Office Action Summary	Application No. 10/719,694	Applicant(s) CRAW ET AL.	
	Examiner John A. Jeffery	Art Unit 3742

DETAILED ACTION

The following title is suggested: "Ventilating and Heating Apparatus With Heater Shielded by Tapered Discharge Duct."

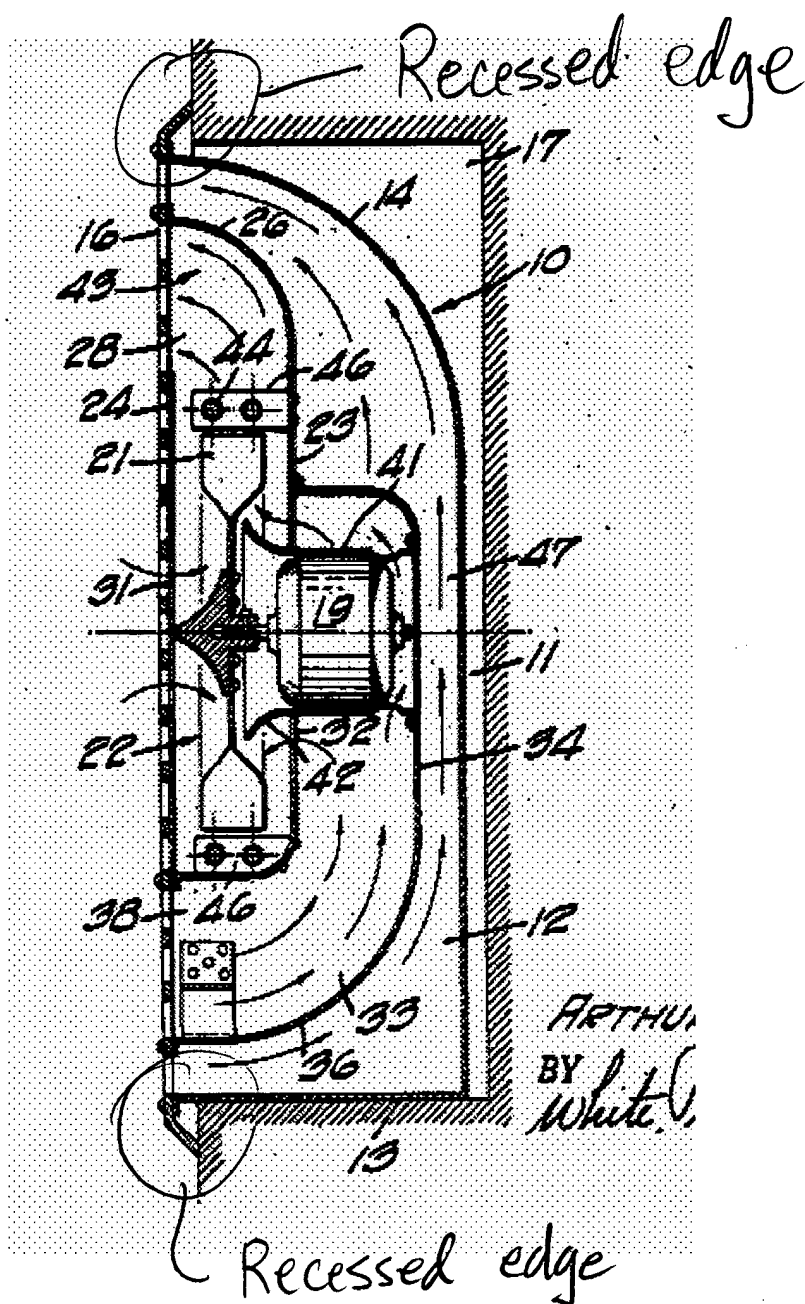
Claims 38, 40-43, and 45 are rejected under 35 USC 102(b) as being anticipated by Kercher (US 1,982,139). Kercher (US 1,982,139) discloses a ventilating and heating apparatus comprising main housing 10, fan housing disposed in the main housing with discharge duct 26, heater 44 secured within the discharge duct having discharge outlet 43. See Figs. 1 and 2. A screened cover 16 has a "discharge aperture" that encompasses the outlets of both ducts 26 and 14; thus, the cover's discharge aperture has a larger cross-sectional area than discharge outlet 43. In addition, Kercher (US 1,982,139) recesses the edges of screened cover 16 with respect to the discharge outlet 43. See Fig. 2 of Kercher (US 1,982,139) which has been enlarged and annotated for clarity.

Applicant argues that Kercher's recessed edge is the edge of grille 16 in its entirety and not the edge of the discharge opening 28. Remarks, at 29. But the scope and breadth of the claim does not preclude the citation of Kercher. The "recessed edges" of Kercher noted in the annotated figure define a periphery of the cover's discharge aperture as claimed. Furthermore, Kercher discloses a screened cover 16 has a "discharge aperture" that encompasses the outlets of both ducts 26 and 14; thus, the cover's discharge aperture has a larger cross-sectional area than discharge outlet 43. In addition, Kercher (US 1,982,139) recesses the edges of screened cover 16 with respect to the discharge outlet 43. The rejection is proper.

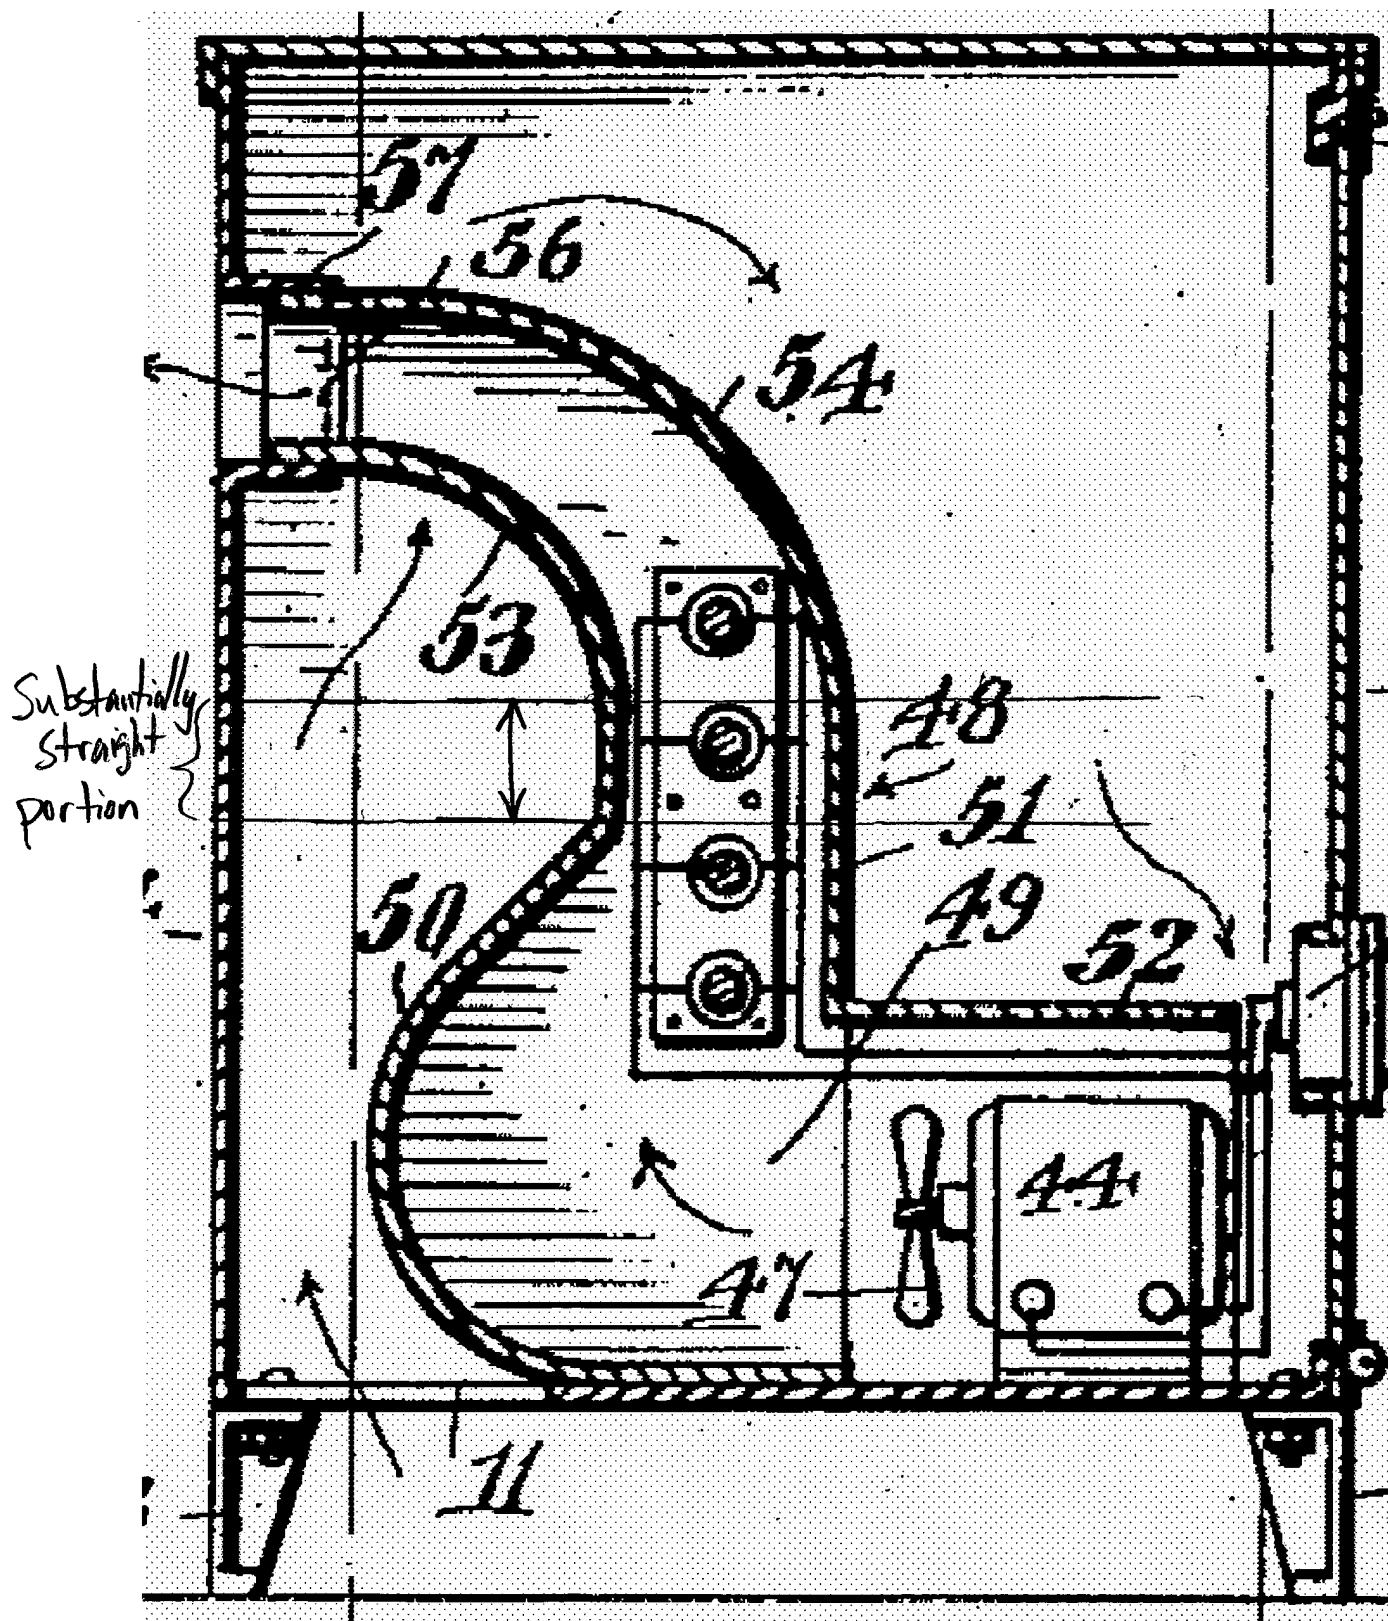
Applicant argues that because Karg's heating unit 41 extends both above and below a "very small" substantially straight portion, it is allegedly not located in a substantially straight portion of the duct. Remarks, at 27. The examiner, however, respectfully disagrees.

First, as applicant admits, a substantially straight portion exists in Karg's discharge duct. The examiner has enlarged and annotated Fig. 5 of Karg below to clarify where this region is located.

As noted in the rejection, although Karg's substantially straight portion is relatively small compared to the remainder of the duct, the heater is nevertheless in the substantially straight portion. Merely because some heater portions fall outside the substantially straight portion does not mean that the heater is not in the straight portion.

The claims as amended do not require that the heater be located entirely in the substantially straight portion. Rather, the claims merely call for the heater to be "in the substantially straight portion" -- a limitation fully met by Karg.
